**AGENDA**  
Planning Commission Meeting  
April 14, 2026 @ 5:30 PM

- 1. Sketch Major Design Review - 702 San Juan Street - Mattie Mae's Social - Restaurant, no drive-through**

## STAFF REPORT

Attachment 1: Conceptual Plans

**A2**  
 Proposed Main Floor Plans

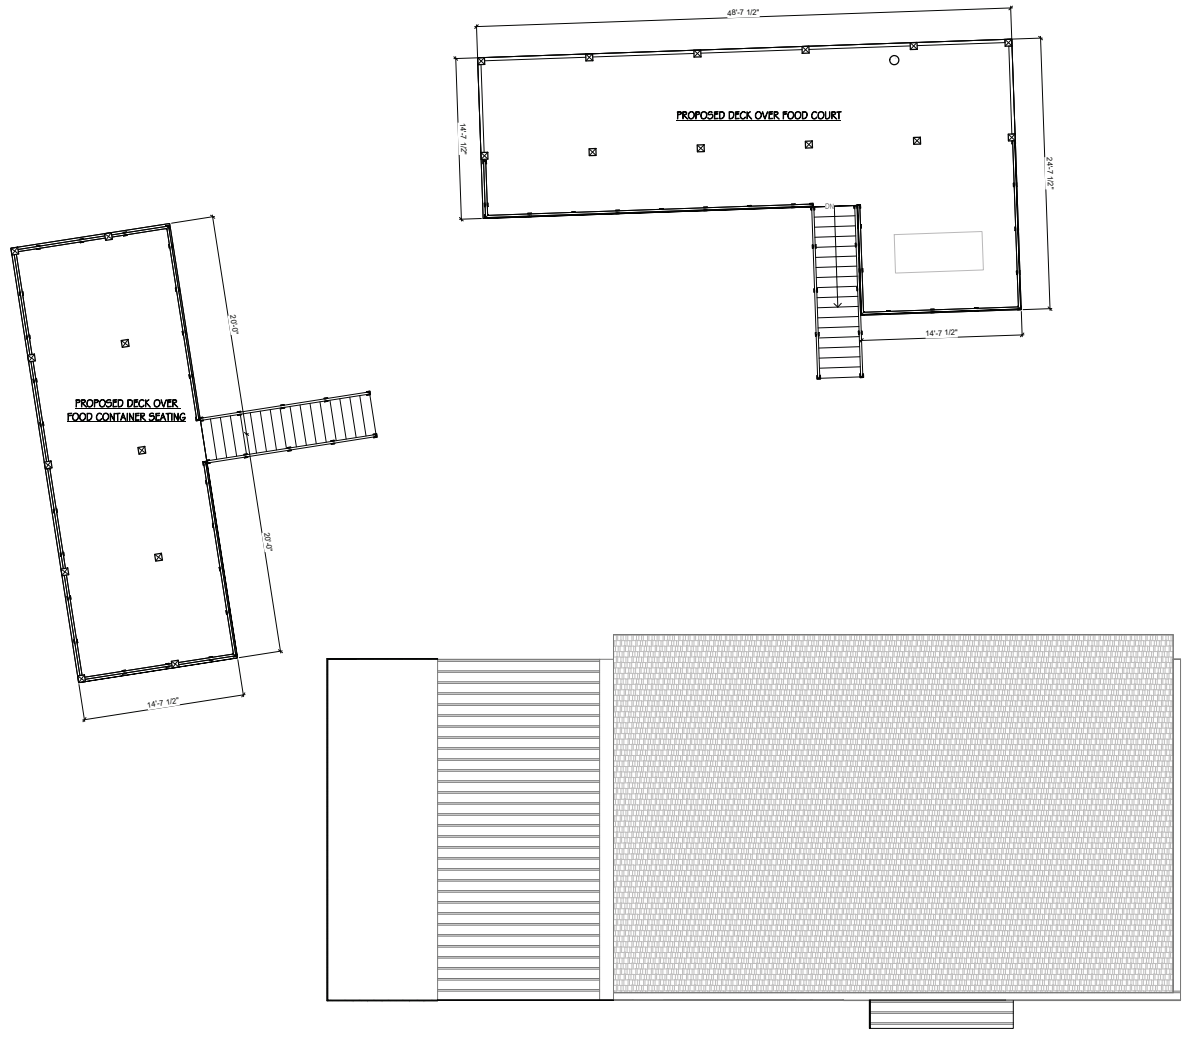
10. Applicant must provide architectural drawings, providing elevations, on the Final Design Review submittal (LUDC 6.4.7).
11. Applicant must include an accessibility ramp to access the entrance of the building in the Final Major Design Review application (LUDC 6.6.5 B7).

Proposed Building Elevations

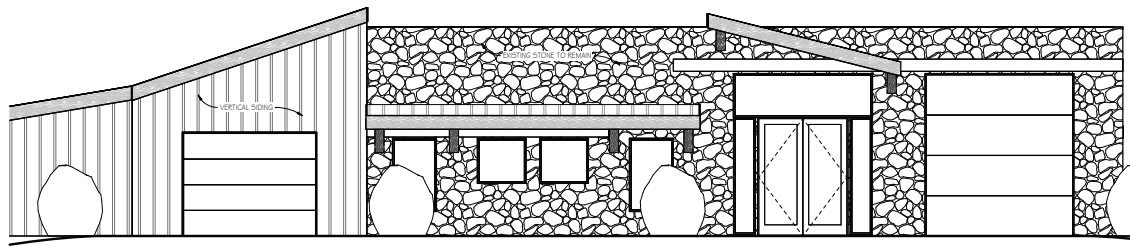
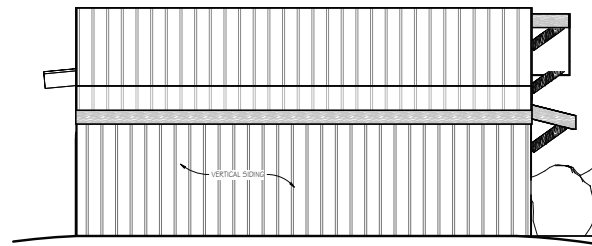
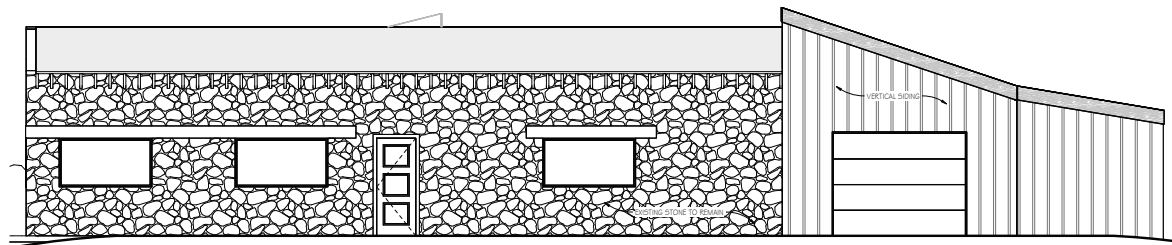
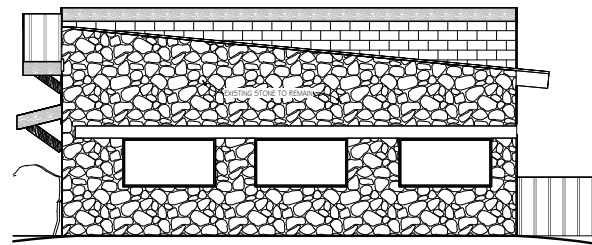
18. Applicant must provide a percentage breakdown of the cladding to be used for the façade of the cargo containers to show that not more than 35% of the siding material is metal (LUDC 6.7.3 B.2d).
